ECE/TRANS/WP.29/GRPE/2006/6/Rev.1
22 March 2006

**REVISED PROPOSAL FOR DRAFT AMENDMENTS TO REGULATION No. 110
(Specific components for CNG)**

Submitted by the expert from the European Natural Gas Vehicle Association (ENGVA)

Fig. 1 Standard connector (receptacle) dimensions [mm]"

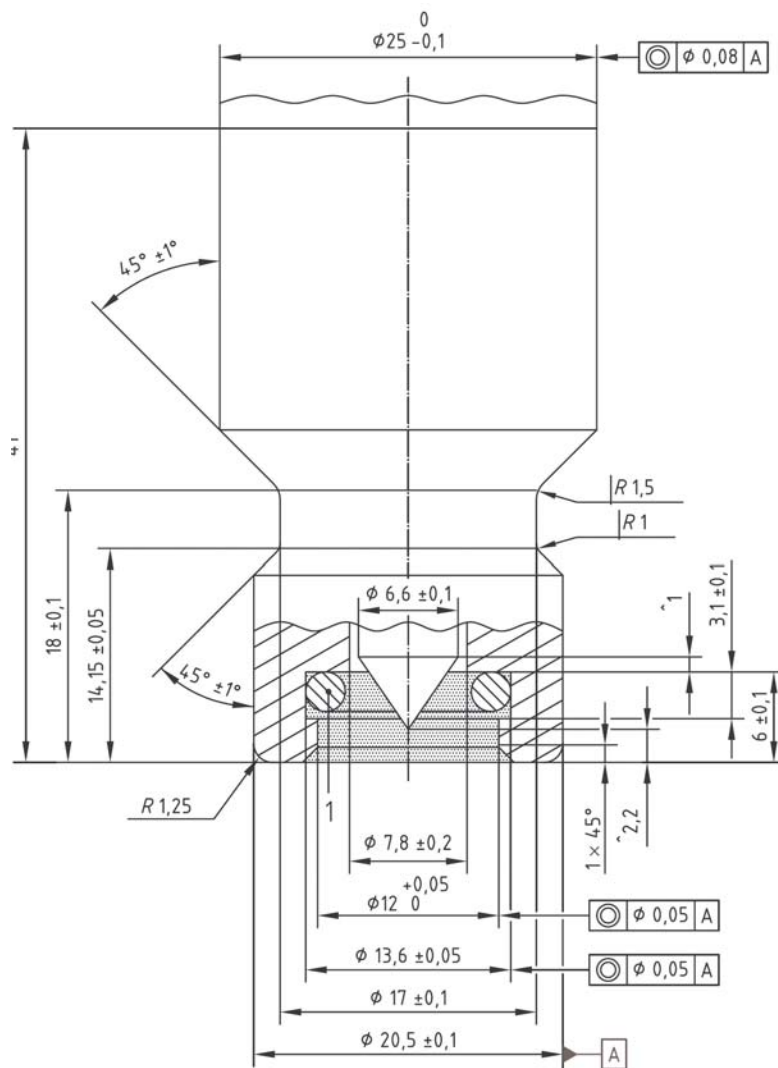
Annex 4F, insert a new paragraph 1.1., to read:

"1.1. The refuelling connector (receptacle) for light duty vehicles (classes M₁ and N₁ vehicles) 1/, designed for service pressure of 20 MPa (200 bar), shall be in accordance to ISO 14469-1 "Road Vehicles compressed Natural Gas (CNG) refuelling connector – part 1: 20 MPa (200 bar) connector" (First edition 2004-11-01). Therefore, for this component, compliance with specific tests contained in this Regulation, particularly to subsequent paragraphs 2. and 3., is not required.

A receptacle shall comply with the design specification detailed in figure 1.
